**Creditview Road Environmental  
Assessment Addendum – Bancroft  
Drive / Sir Monty's Drive to Old  
Creditview Road**

**City of Mississauga**

**February 13, 2026  
300060824.0000**

**Figure 3 - Noise Wall Recommendations**

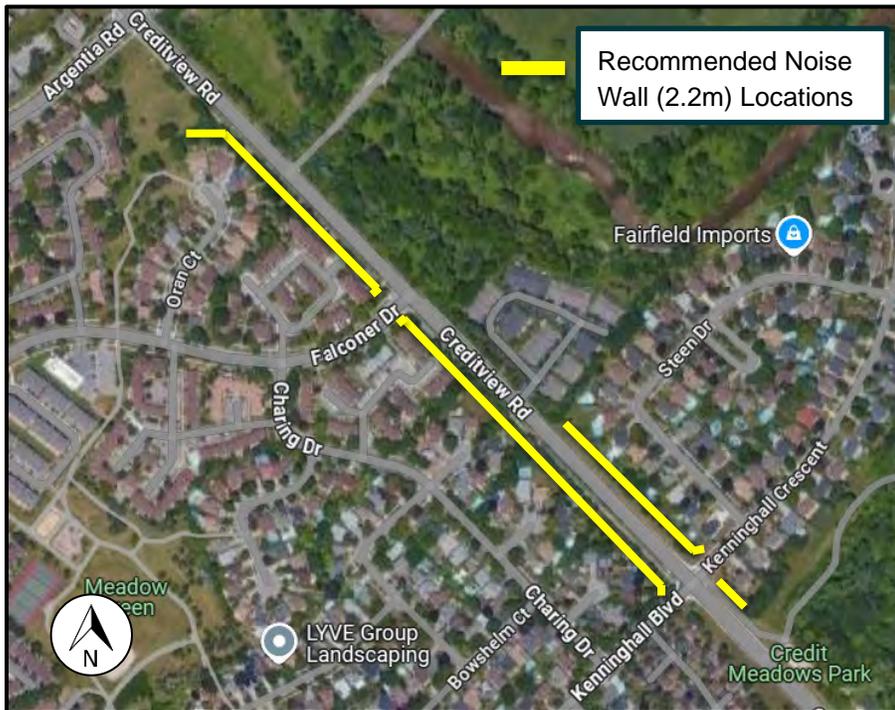
The noise wall recommendations in the 2016 MCEA Study have been updated based on a review of the adjacent grading, truck restrictions, and future posted speed limit (50 km/h) on Creditview Road within the Addendum limits for the 2041 horizon (see Figure 3). The review determined that 2.2 m is a sufficient height for the new noise wall locations proposed in Figure 3. The proposed noise wall at 59 Kenninghall Boulevard was removed from the revised preferred solution as the noise wall is not directly adjacent to the noise sensitive area, and not consistent with the City's noise wall policy. In addition, the noise wall would be less effective due to the grade elevation and line of sight, to support effective noise attenuation. The proposed noise wall at 6650 Falconer Drive was removed from the revised preferred solution as it is not adjacent to the

Creditview Road right-of-way and is also not consistent with the City's existing noise wall policy. The updated Noise Memo is provided in Appendix H.

**Figure 4 - Conceptual Cross-section between Falconer Drive and Argentia Road**

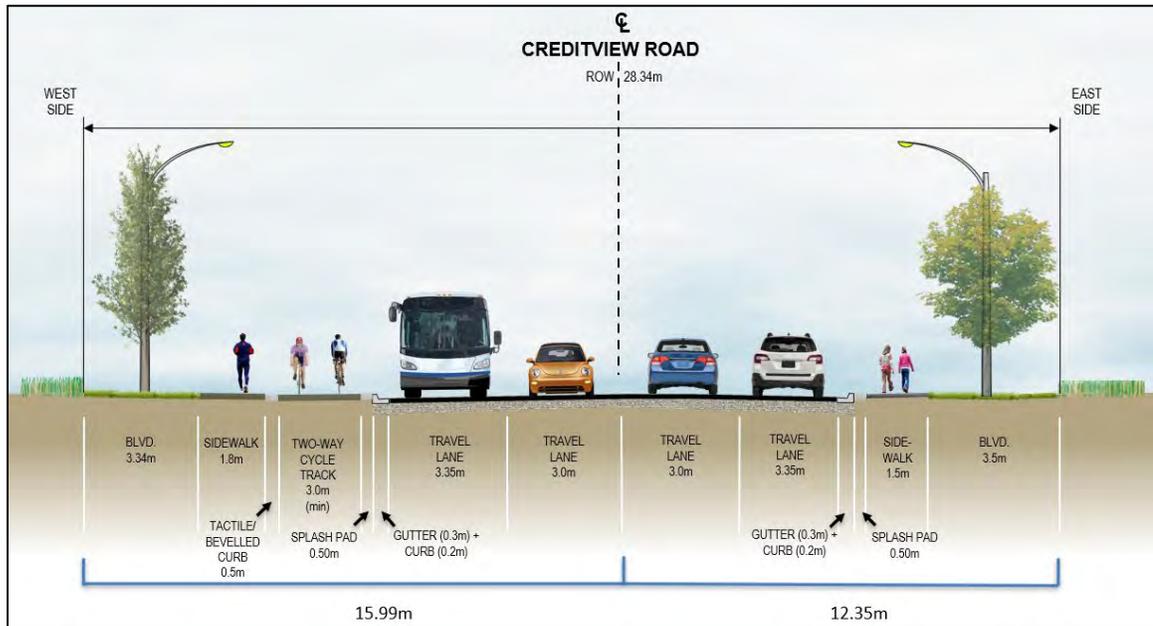
Therefore, for the purposes of this Addendum, a cross-section was produced at the most constrained point along the Study corridor to illustrate a conceptual design whereby target widths for active transportation facilities and lane widths meet the City's draft Complete Streets Guide and Book 18 of the Ontario Traffic Manual. The Creditview Road Study corridor is most constrained between Falconer Drive and Argentia Road, where the available right-of-way is approximately 28 m, as shown in Figure 4.

The conceptual cross-section shown is subject to further analysis to confirm that there are no site-specific constraints and / or adverse environmental effects that would impact its feasibility. The following additional considerations are proposed to be assessed as part of detailed design:

**Figure 3: Southbound Left Turn Lane at Rivergate Place**

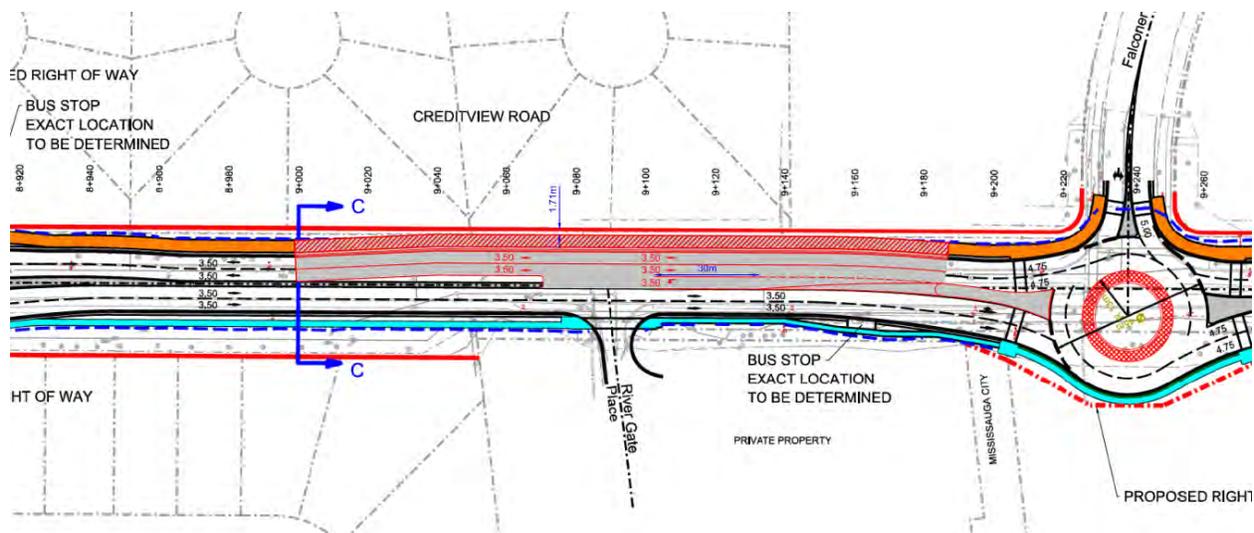
The proposed widening (see Figure 3) for the left turn is exclusively to the west side, therefore, the geometry of the roundabout approach will not change, and all geometric criteria for the roundabout will be maintained. The immediate exit geometry from the roundabout was also not changed.

- The boulevard on the west side will be reduced from the current 3.85 m (including the Noise Barrier – see Figure 2) to approximately 1.7 meters (design is based on PDF drawing)
- Proposed Hydro / Illumination poles would have to be placed within the reduced boulevard width.
- Proposed other utilities (telecommunication etc.) would have to account for the narrow boulevard.
